CITY ENGINEER

MEMORANDUM

Reference: Case No. PD-270-RBN, The Avenue at Denton Tap, a zoning change request from Commercial to a Planned Development to allow 29 multifamily units and 8,575 square feet of office/retail uses on 1.77 acres of property located at the northwest corner of Southwestern Boulevard and South Denton Tap Road.

CASE NO. PD-270-RBN, The Avenue at Denton Tap

Site Plan

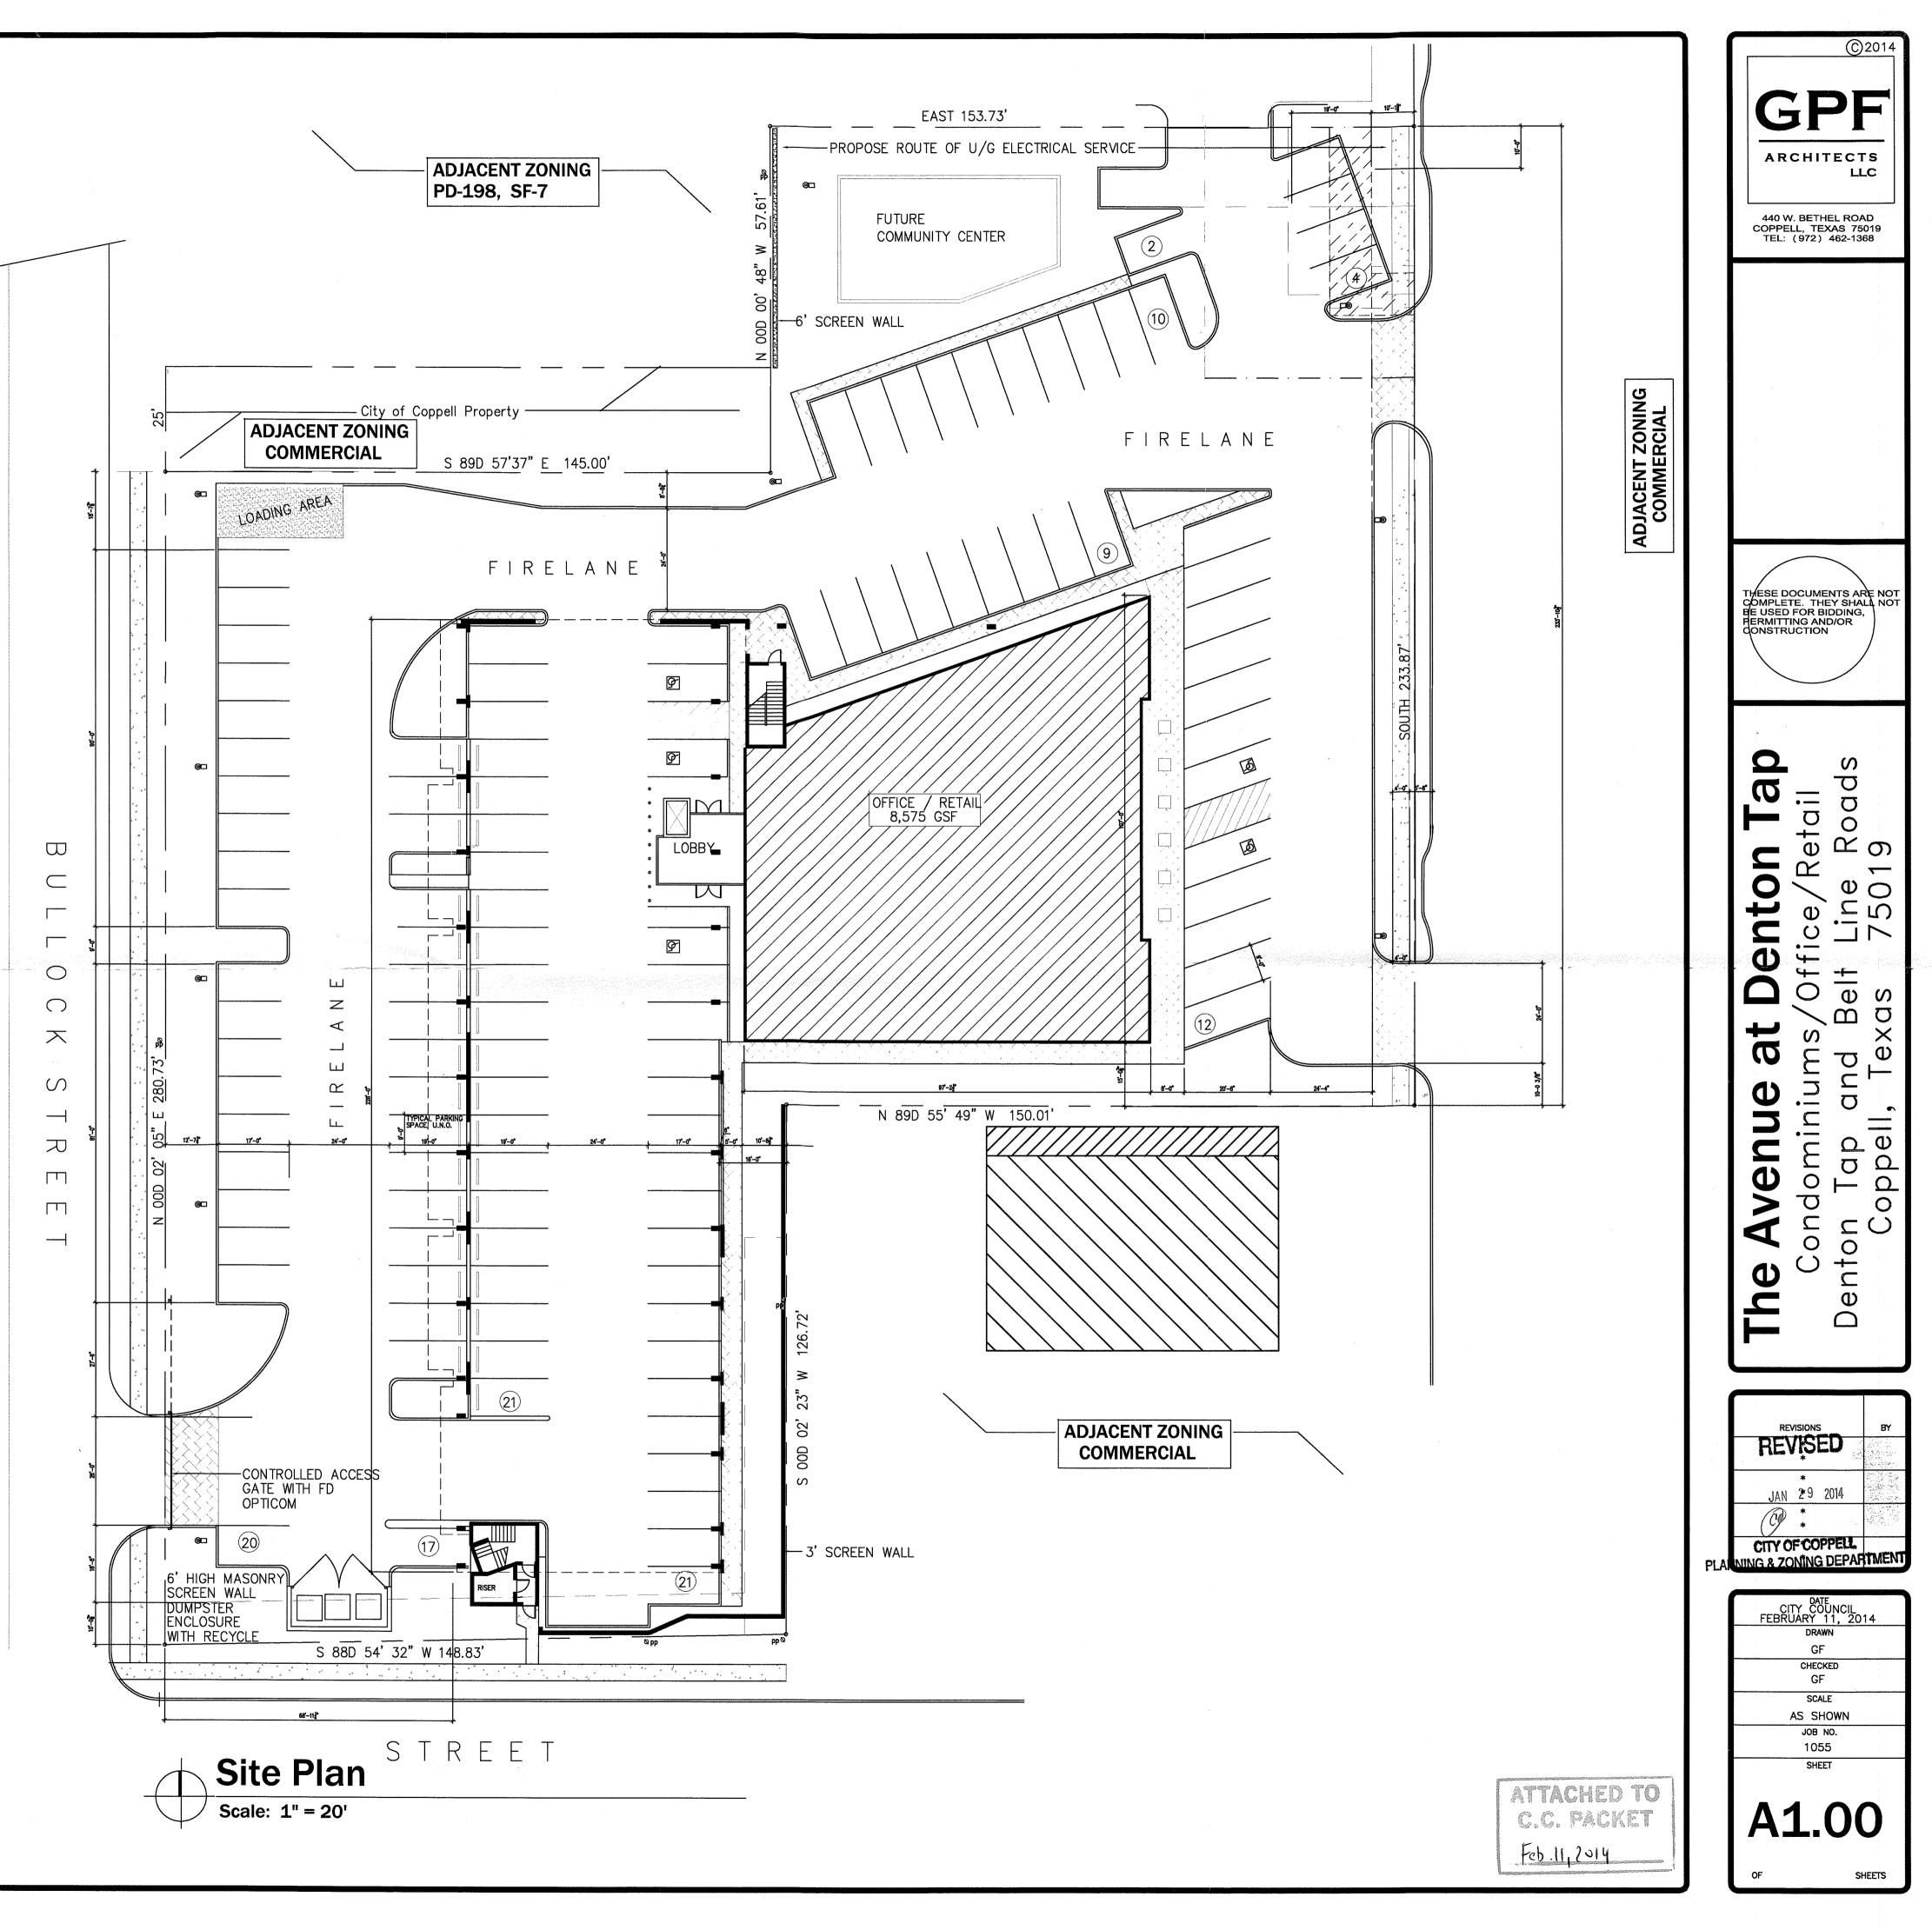
A 36-foot setback is proposed along the northwest property line, which is adjacent to a 25-foot right-of-way providing a greater separation from the residential neighborhood. The main building is 63 feet from the Denton Tap Road right-of-way where the RBN District calls for a building to be no more than 15 feet from the lot line. Staff can support this deviation, as both a drive and parking are warranted for the office/retail use.

This proposal exceeds the 116 parking space requirement by providing 119 spaces. Both the *Comprehensive Plan* and the RBN District encourages structured (garage) parking. In this development 41 of the 119 spaces are contained within the structure. It is recommended that this parking area on the first floor be better screened with a three-foot masonry wall incorporated into each façade and this has been listed as a condition of approval. Beyond the structured parking are 41 spaces in a parking lot. This area is proposed to be screened with a 12 foot wide landscaped area east of Bullock Street. The proposed off-street parking and drive (similar to a slip street recognized in the Comprehensive Plan). The proposed parking located on the Denton Tap Road side is angled with a one-way drive to provide an opportunity for streetscaping without actually having dangerous on-street parking on Denton Tap.

- 8. Include three 150-square-foot landscape islands with an overstory tree within the proposed surface parking area where not under the structure. No more than 15 spaces are typically permitted without an island and one island is required at the end of each parking row.

- 16. Include a gate with controlled access (include opticom for Fire Department) at the southwest access point off of Bullock.
- 17. Relocate the dumpster enclosure to the south end of the project.

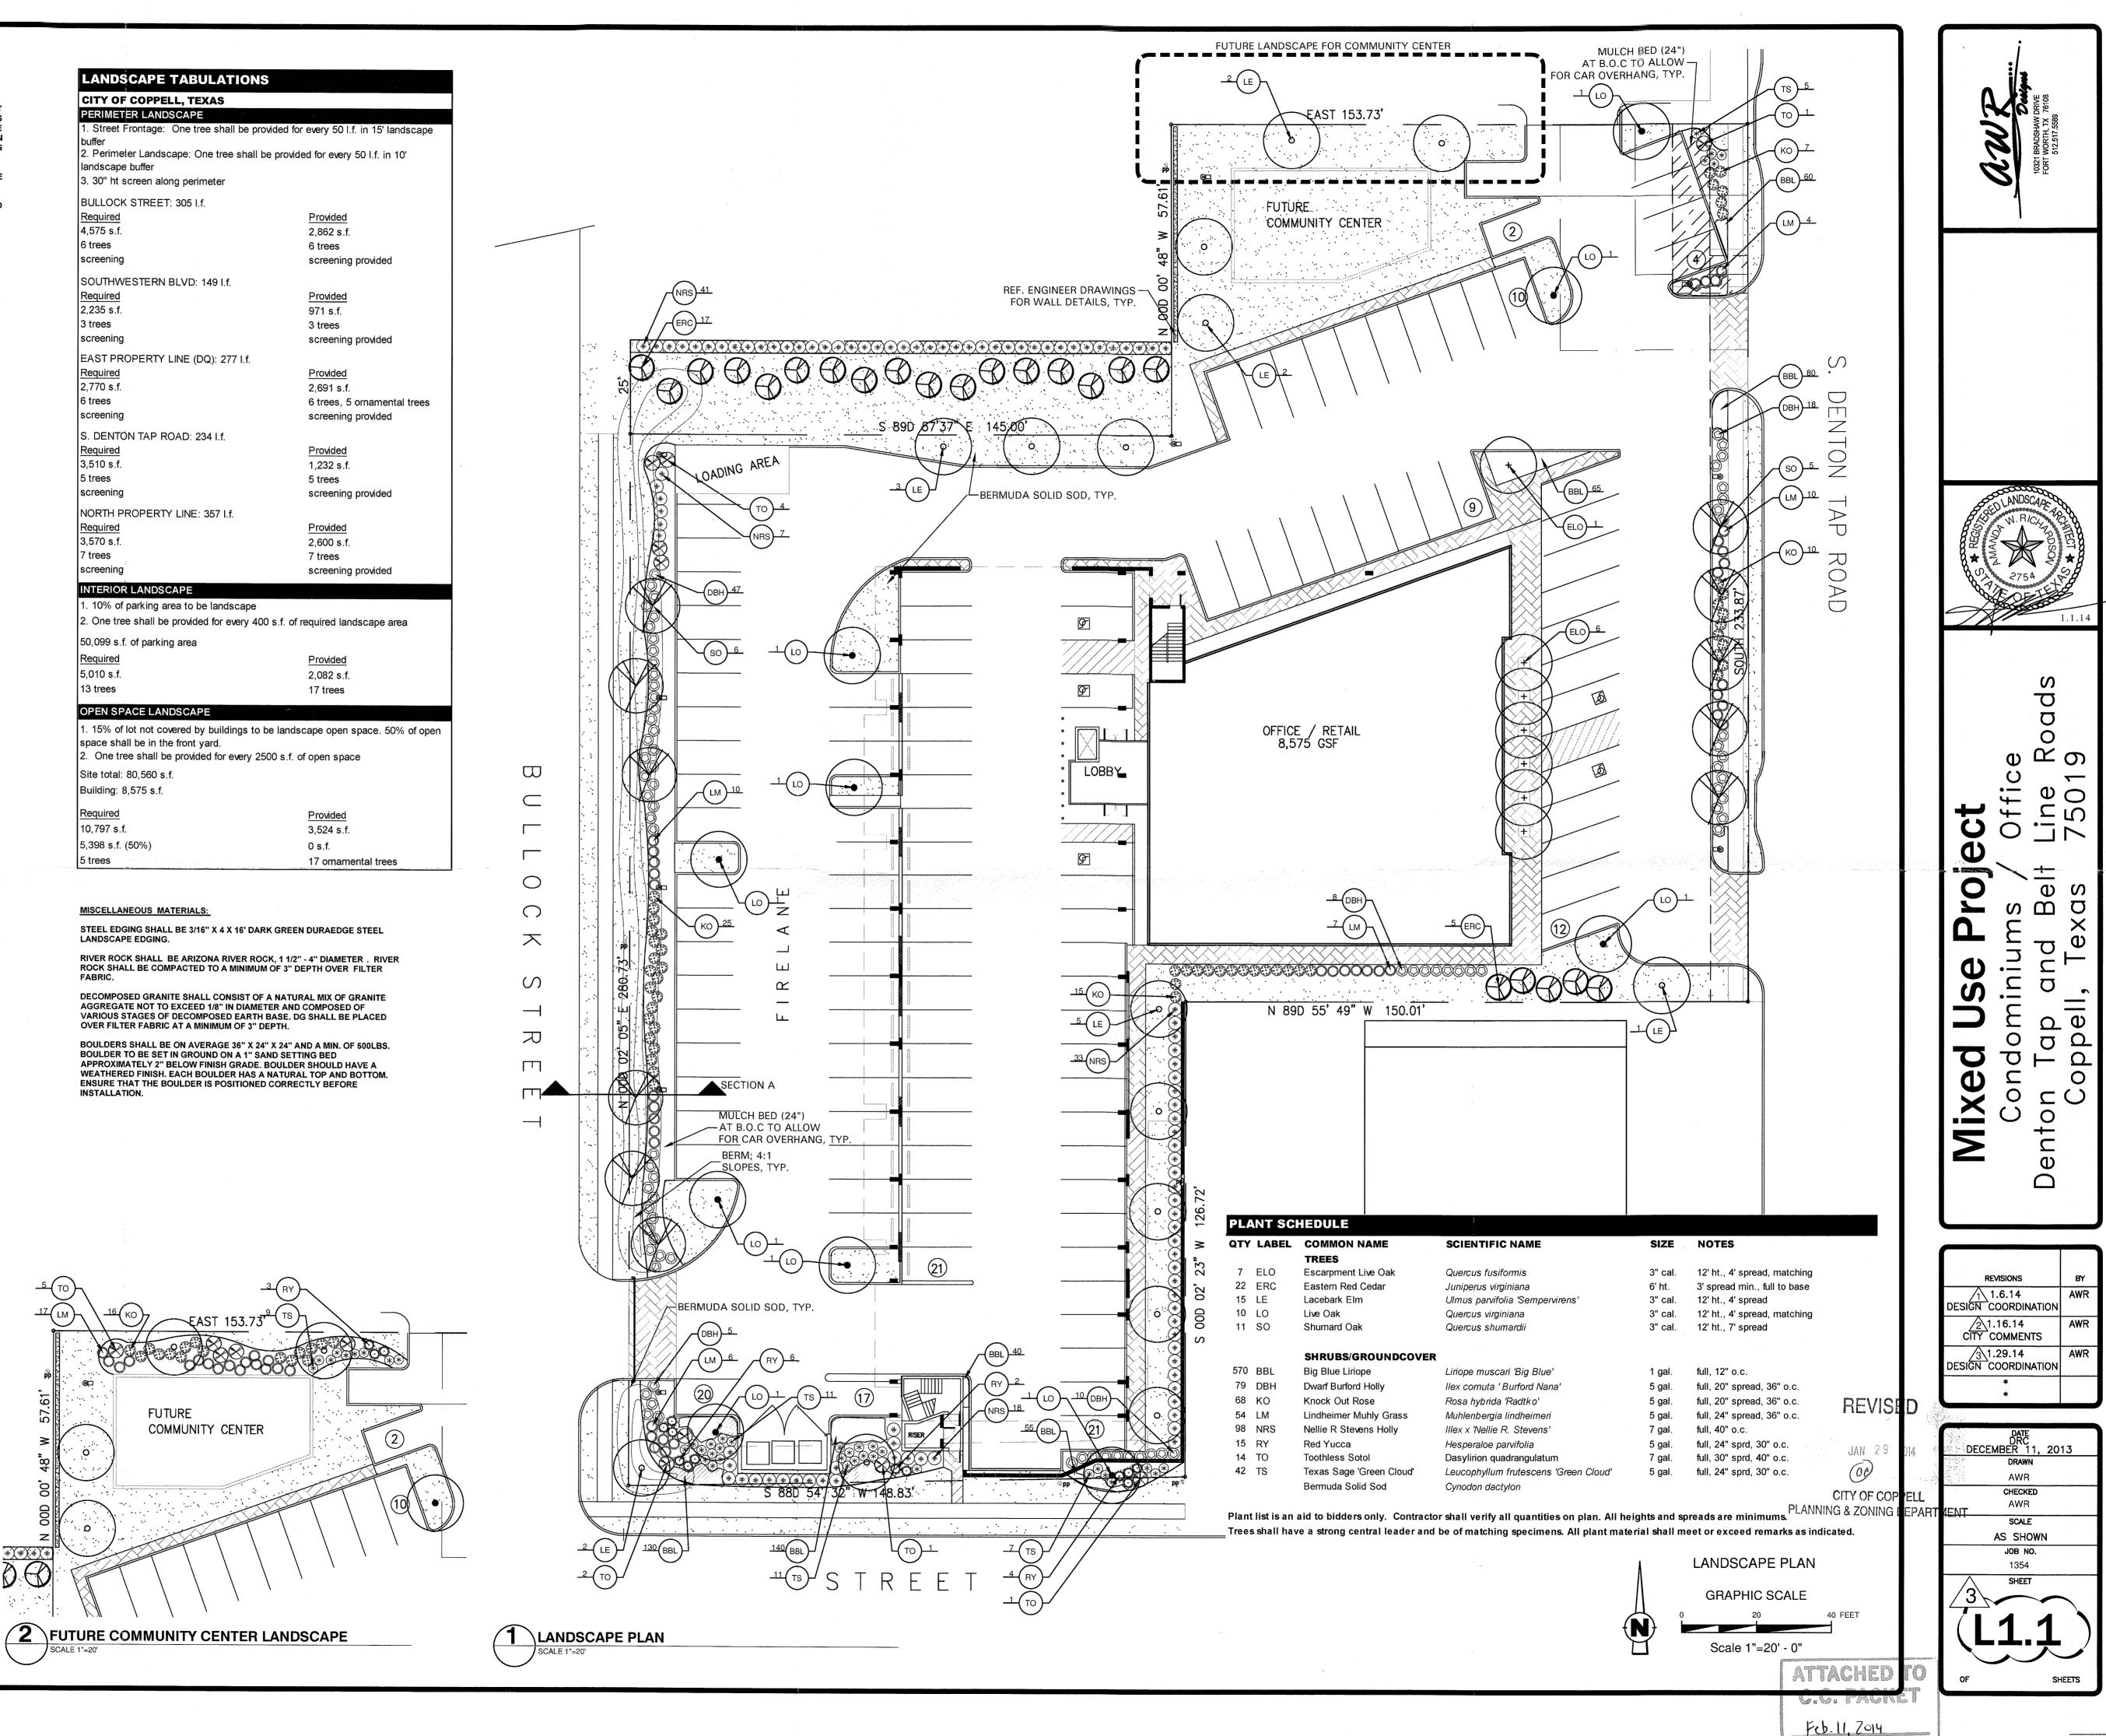
The landscape areas within a RBN District are different than the typical business zoning districts where under the RBN, a minimum 15% open space/common area is required. The proposal indicates that 17% has been provided. The streetscaping of the retail/office area is adequate where street trees are being provided. However, additional landscape islands are being recommended in the parking lot where there is no structure over the parking. Not more than 15 parking spaces are typically permitted without an island and one island is required at the end of each parking row; therefore, three islands are recommended. Also, the applicant has agreed to add an evergreen area of landscaping (containing Nellie R. Stevens and Eastern Red Cedars) to the 25 foot right-of-way strip located northwest of the property to better buffer/screen this proposal from the existing residential neighborhood.

- 11. Submit Future Community Center plans to the Director of Planning for administrative review, prior to permitting or construction.
- 12. Label the 25-foot right-of-way northwest of the site as City of Coppell Property. Include Eastern Red Cedars and Nellie R. Stevens south of the existing fence.

- 13. Overhead electric line shall be relocated and buried.
- 14. List all requested variances to the RBN District in the PD Conditions table.
- 15. Revise the Landscape Plan to include interim and future landscaping for the "Future Community Center" portion of the site.
